**Re: Response to Preliminary Geologic/Seismic Hazard Review and
Supplemental Geologic Investigation
Proposed Senior Housing Facility
4200 Dove Hill Road
San Jose, California
Langan Project No.: 770619902**

This letter presents our response to review comments by the San Jose Department of Public Works (SJDPW) dated 25 September 2015 regarding our Geotechnical Investigation and Geologic Hazard Evaluation report dated 30 June 2015 for the proposed senior Housing Facility project at 4200 Dove Hill Road in San Jose, California. SJDPW had several comments (designated 1 through 13 in their review letter) regarding geologic/seismic hazards evaluation and mitigation at the site; a copy of the review letter is included in Appendix D. The project will consist of two new buildings, designated as Buildings A and B; both buildings are proposed to be four stories above a podium level as shown on Figure 1.

ENGINEERING GEOLOGIC MAP

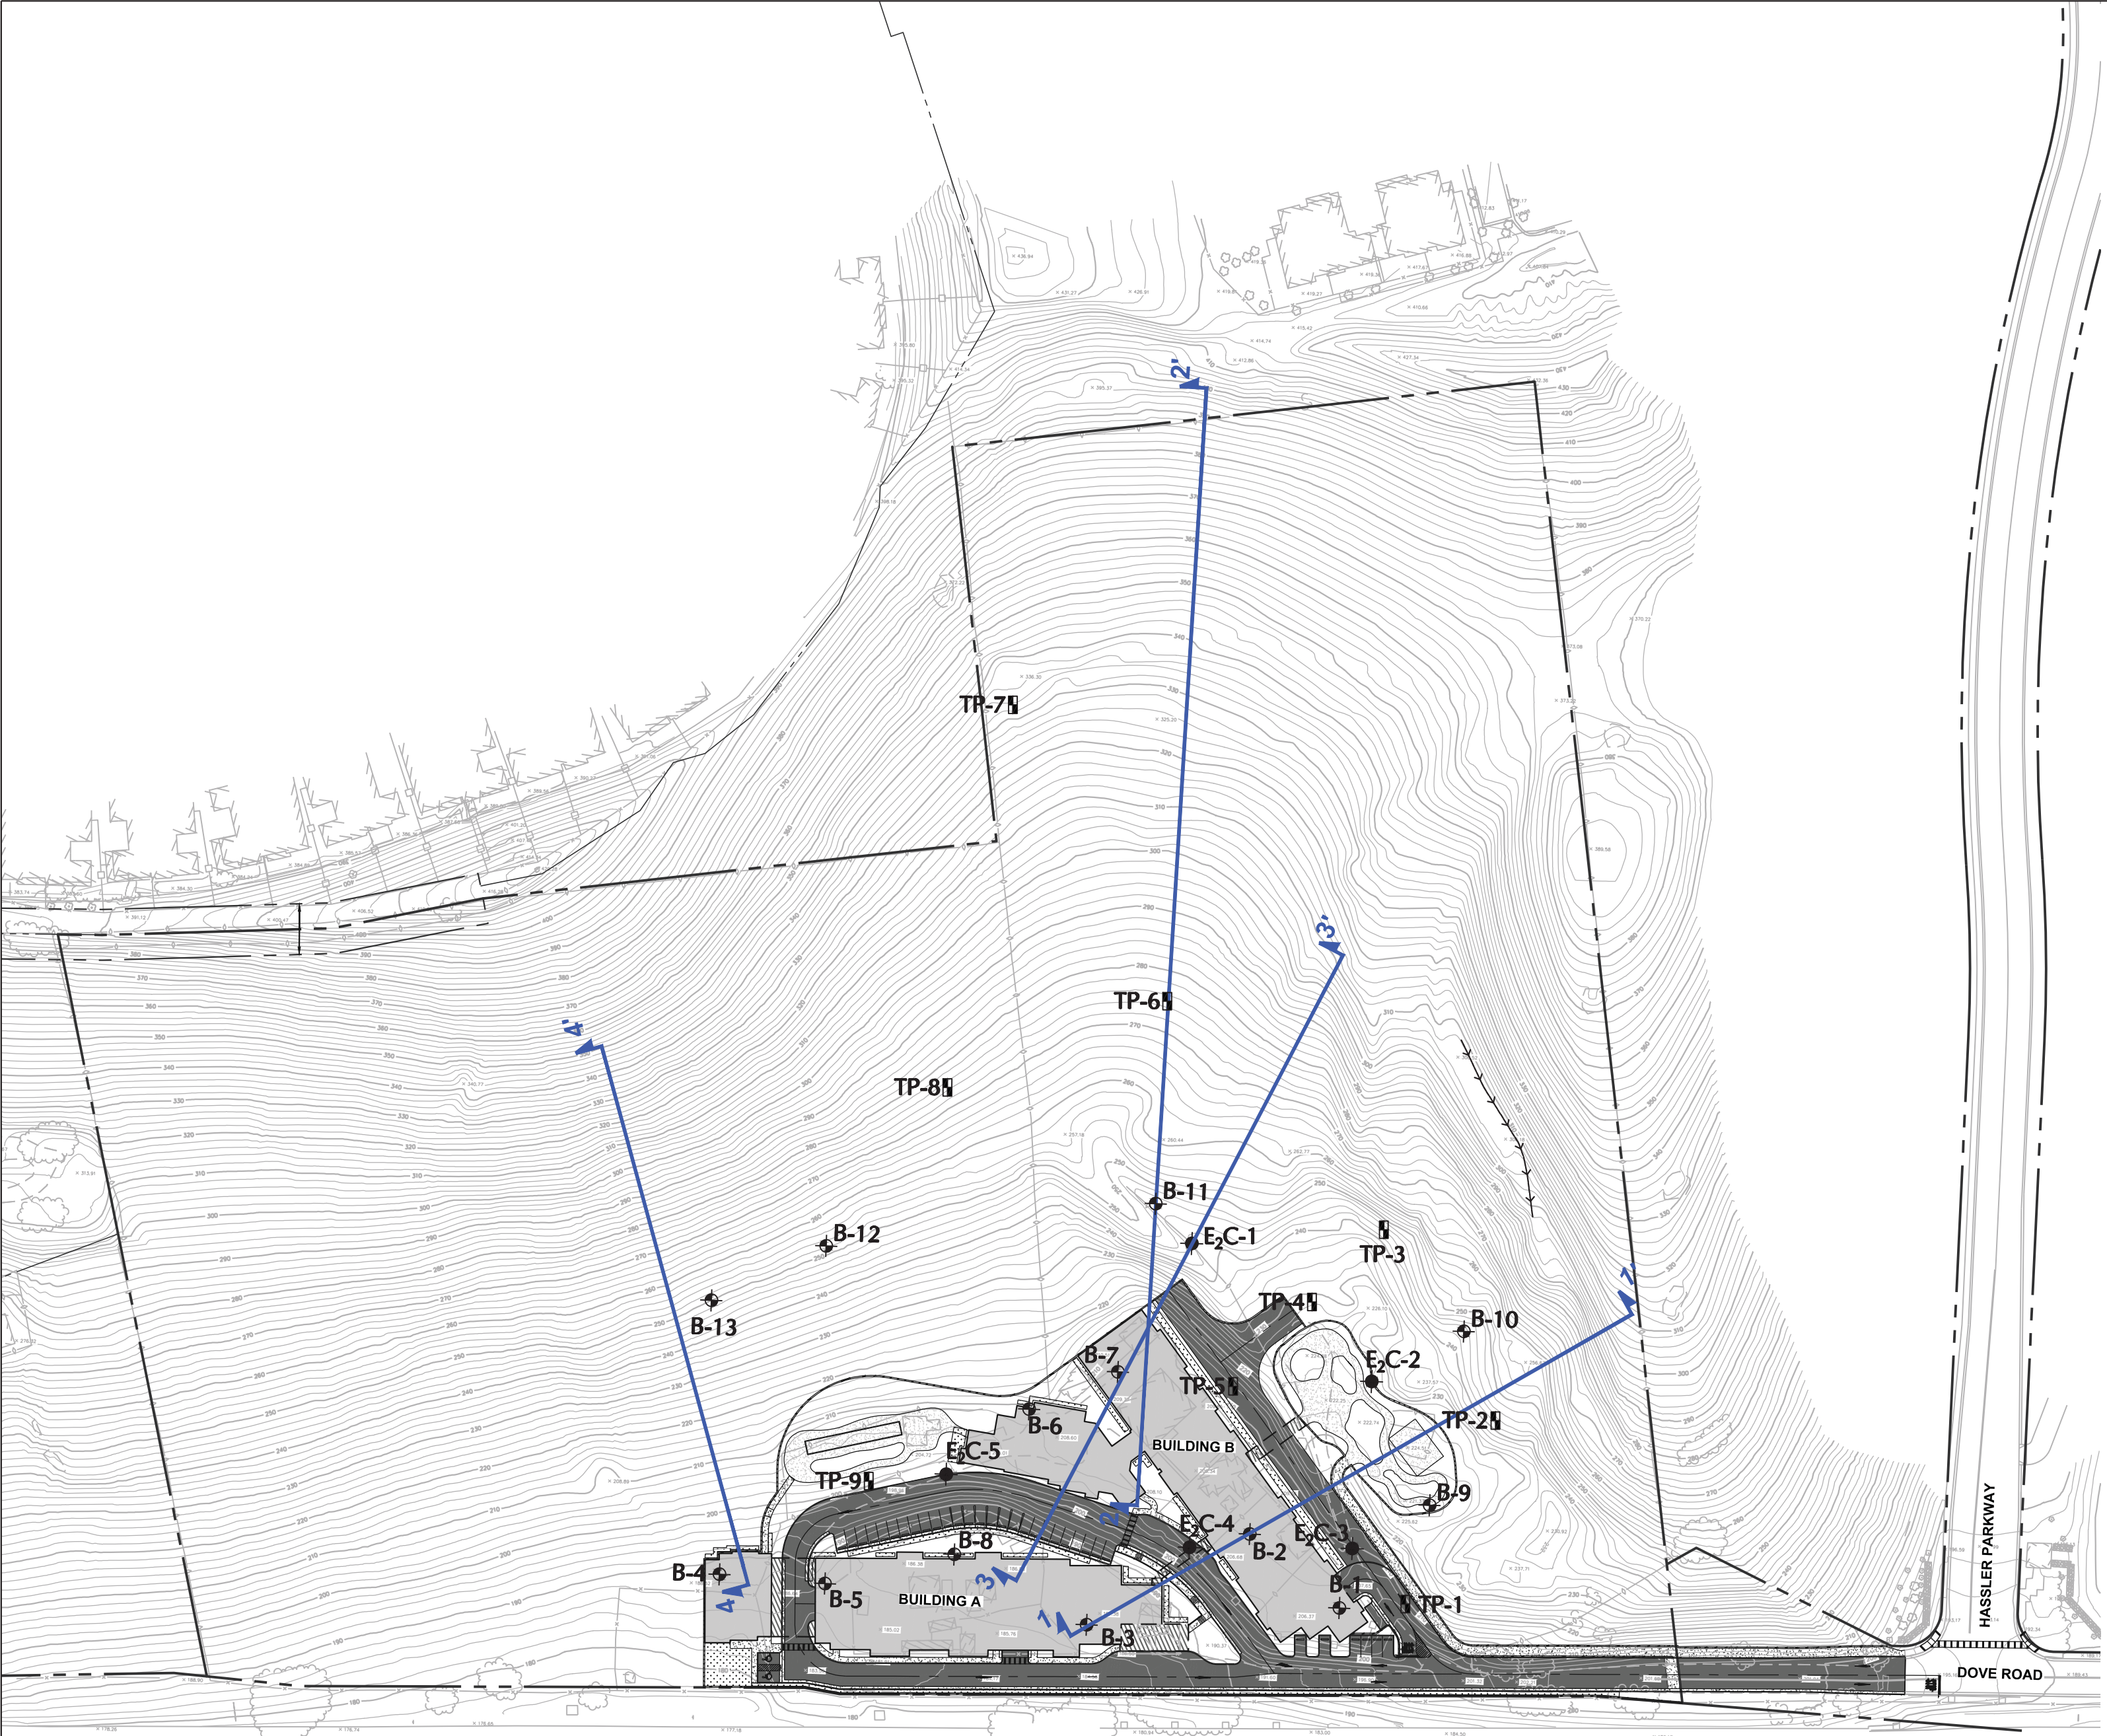
SJDPW was concerned that the existing landslides on the northern and southern slopes of the site could mobilize and impact the proposed development under potential high groundwater seepage conditions. SJDPW requested that the landslides be characterized in greater detail and evaluated under these conditions.

As discussed in comment 1, two landslides were identified and investigated on the southern portion of the site (Figure 2). Boring 10 and Test Pit 2 characterized the landslide materials. The proximity of the two landslides to each other indicates a similar failure trigger. Aerial photo reconnaissance, geomorphology, and subsurface investigation all indicate the southern steep hillslope was quarried and graded to incorporate several access roads. The upper access road demarcates the headscarp region of both landslides. Slope gradients upslope of the headscarps range from 47° to 37°, while gradients to the east range from 26° to 33°. Therefore, it appears the over-excavation of the quarry face in the region of landslides coupled with concentrated runoff from the access road were the primary triggers for these slope failures. See Figure 3 for the southern landslide deposits thickness and geometry.

IDEALIZED SUBSURFACE PROFILES
1-1', 2-2', 3-3', AND 4-4'

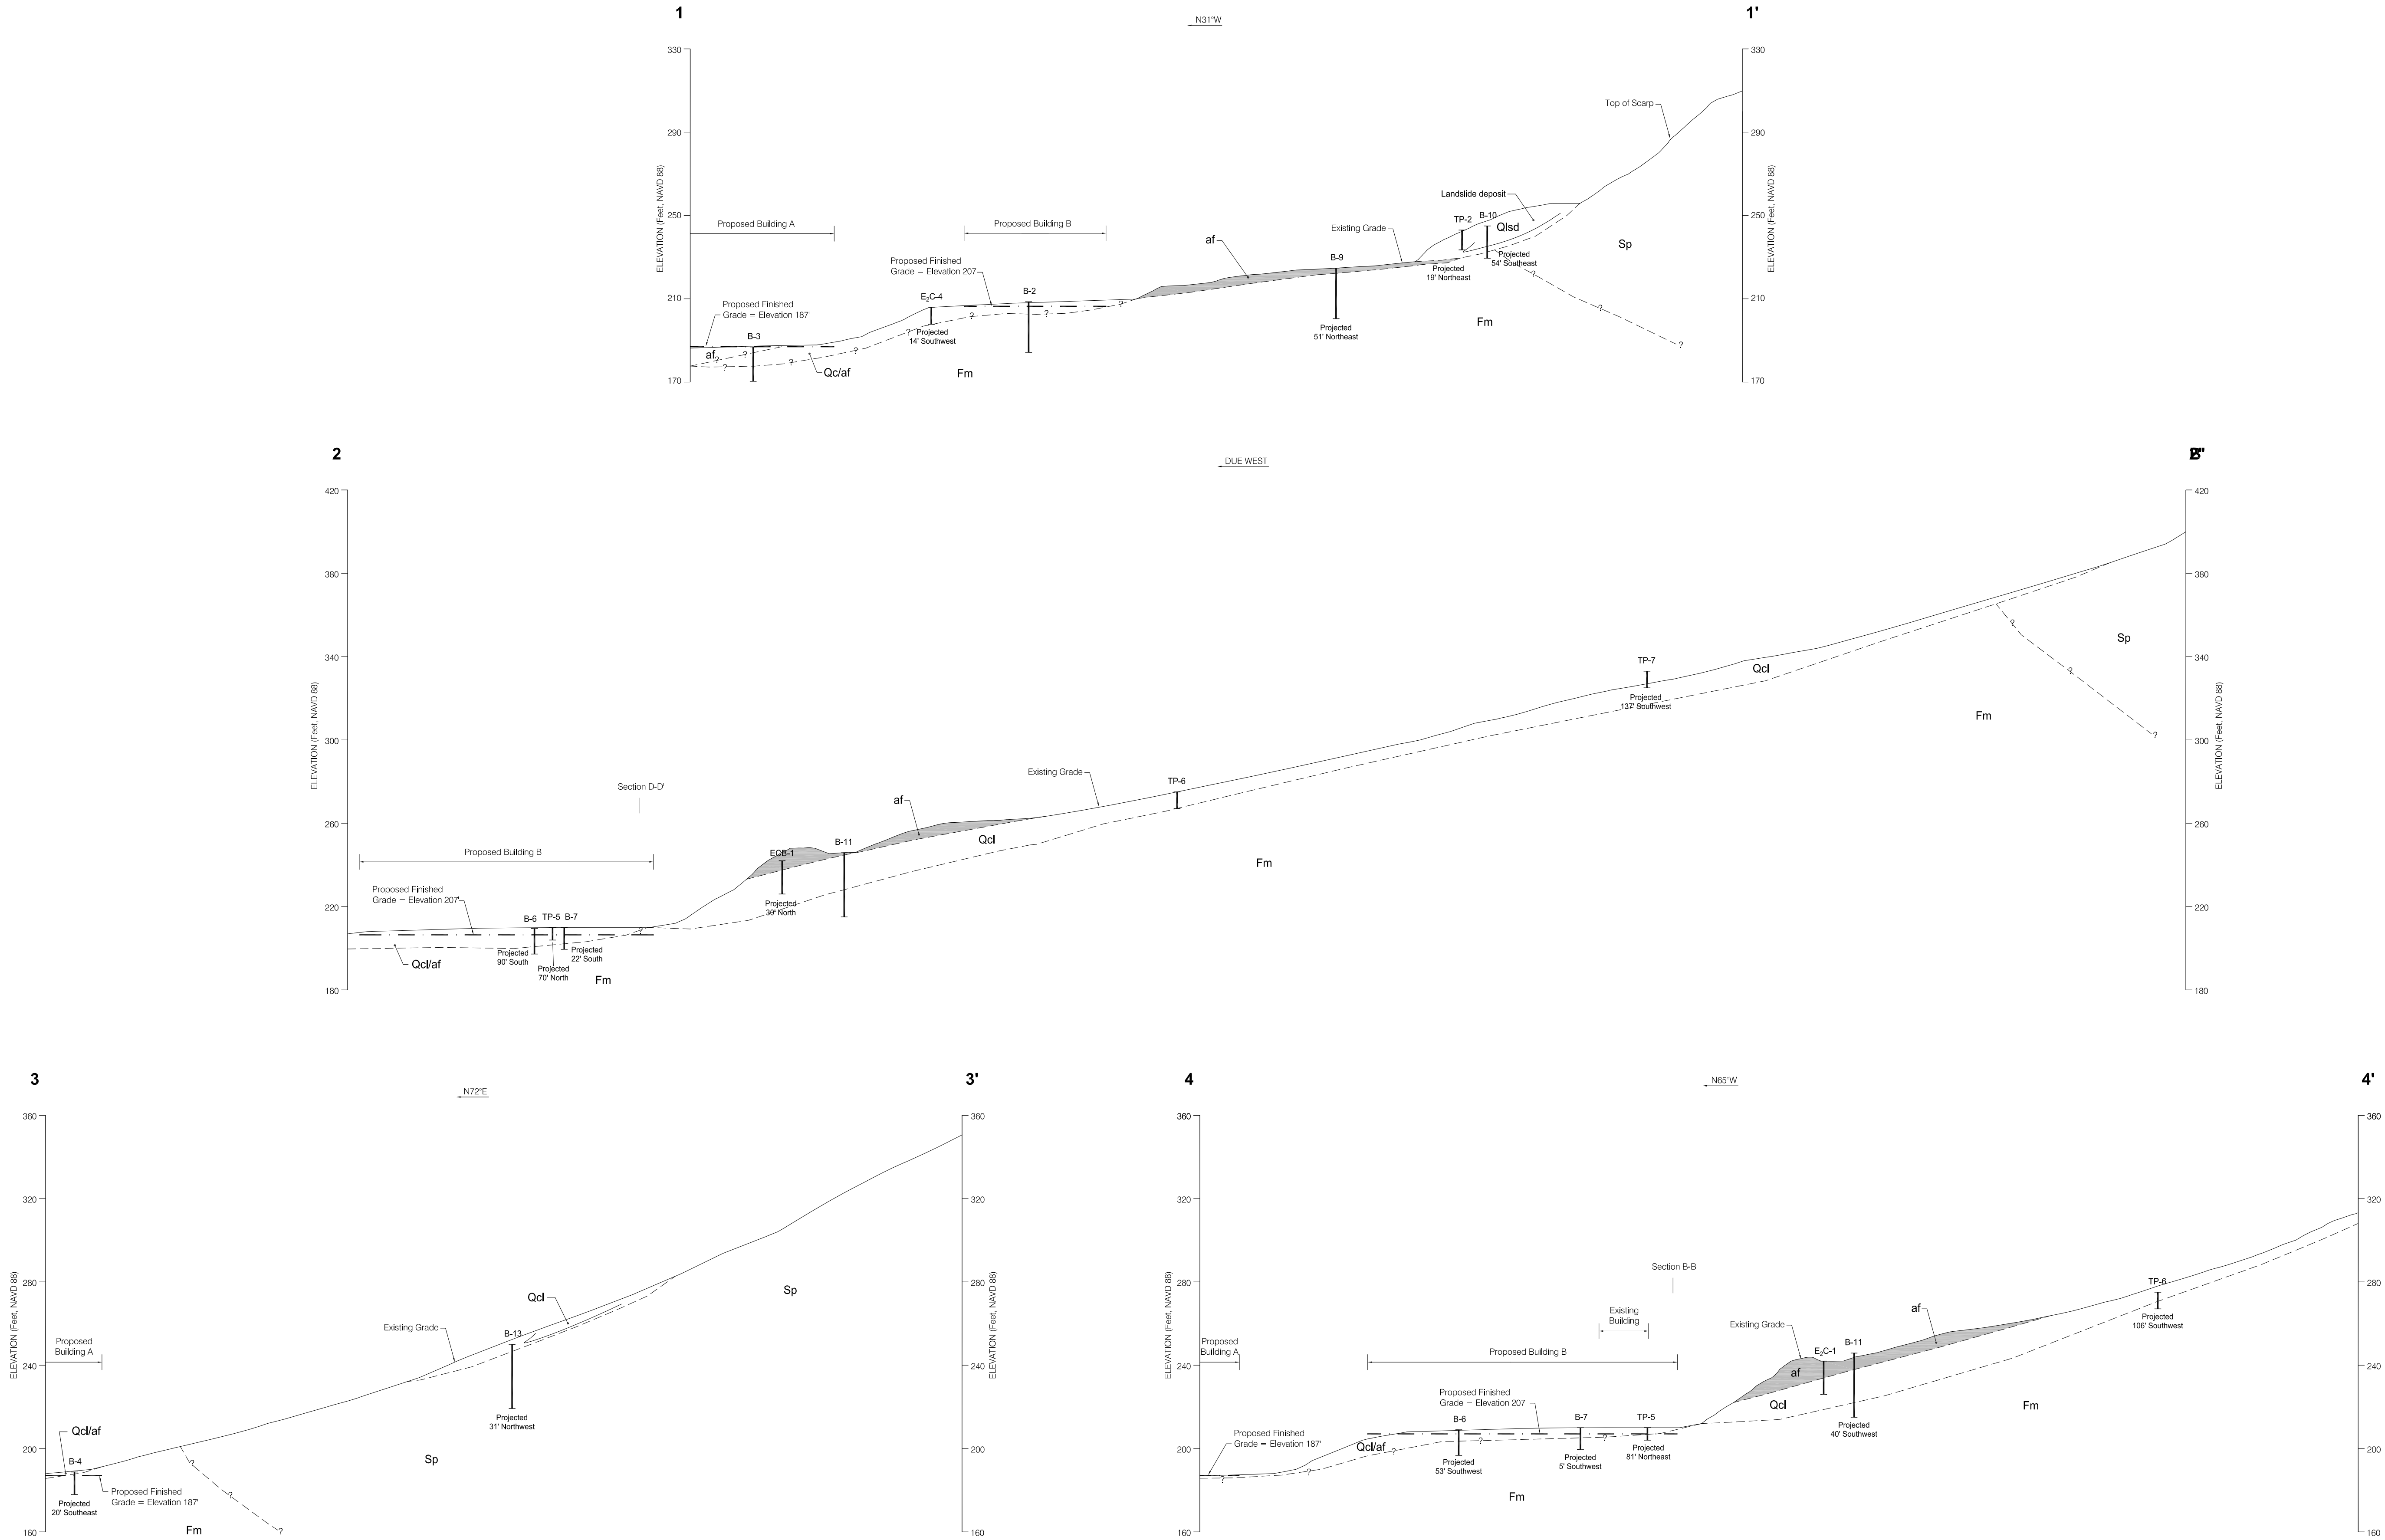
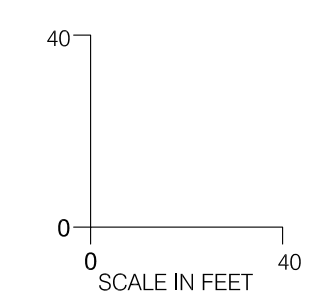
- the steep slopes presented on “idealized” subsurface profiles (Figures 6-8 of our previous report) upslope of the proposed building sites may generate damaging soil slips, debris flows and slides, as well as earth flow type landslides.
- the existing landslides delineated on the Engineering Geologic Map, Figure 4, may be susceptible to re-mobilization and earthquake induced landslides.

SJDPW stated that the recommended 3:1 grading of the slope southeast of Building B to mitigate future slope instability is not shown on the proposed grading plan and that it is unclear whether this will completely remove the landslide on the cut slope. SJDPW recommended performing a supplemental subsurface exploration to determine the thickness of the landslide southeast of Building B.

Fill material situated south and southeast of proposed Building B was the focus of our fill characterization. Similar to the colluvium, the fill was composed of sandy clay to clay. Figure 3, Idealized Subsurface Profiles, depicts landslide, colluvium and fill thickness based on our supplemental subsurface investigation. Idealized subsurface profiles 1-1', 2-2', 3-3' and 4-4' correspond to the same locations as A-A', B-B', C-C' and D-D', respectively; however, we have revised the subsurface geology based on the additional exploration.

The geometry of the landslide along the southern portion of the property is best depicted by Subsurface Profile 1-1' (Figure 3). We recommend the landslide deposits be removed and the slope graded to an inclination of 3:1 (horizontal:vertical). This method would remove most of the landslide deposits. In addition, we recommend excavating a keyway into firm material at the toe and benching into the landslide deposits. Up to a 5 foot deep thick wedge of landslide deposits will remain. The depth of the keyway and benches will be determined during grading. It is our opinion that the remaining landslide deposits keyed and benched at a grade of 3:1 (horizontal:vertical) will pose a low risk of slope instability.
